REGULATION 4 OF THE INFRASTRUCTURE PLANNING (CHANGES TO, AND REVOCATION OF, DEVELOPMENT CONSENT ORDERS) REGULATIONS 2011 APPLICATION TO MAKE A NON-MATERIAL CHANGE TO THE OAKLANDS FARM SOLAR PARK ORDER 2025 (SI 2025/739) AS CORRECTED BY THE OAKLANDS FARM SOLAR PARK (CORRECTION) ORDER 2025 (SI 2025/1070)

EN010122 – Oaklands Farm Solar Project Non-Material Change Application.

Coton-in-the-Elms Parish Council

nsip-documents.planninginspectorate.gov.uk/published-documents/EN010122-000819-EN010122 D7 6.1 ES Chp8 Appx 8.1 Flood Risk Assessment and Outline Drainage Strategy Clean.pdf

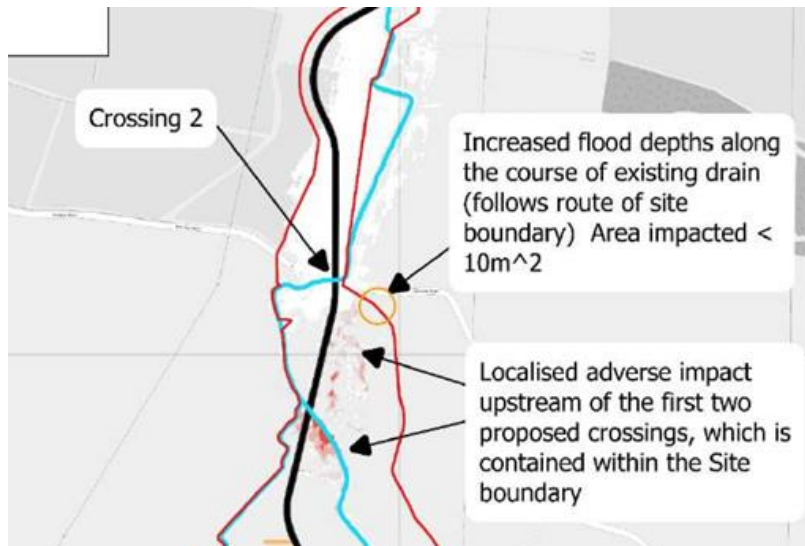
Please note for all these conditions it does not fulfil the requirements of the Development Consent Order (DCO) in that the submitted details do not “include the plans and strategies referred to in the flood risk assessment” as required by Requirement 17 part 2 of the DCO as they are not in accordance with the flood risk assessment which shows clearly land near Rosliston road may flood by up to 20cm. Please refer to FRA document dated Dec 2024.
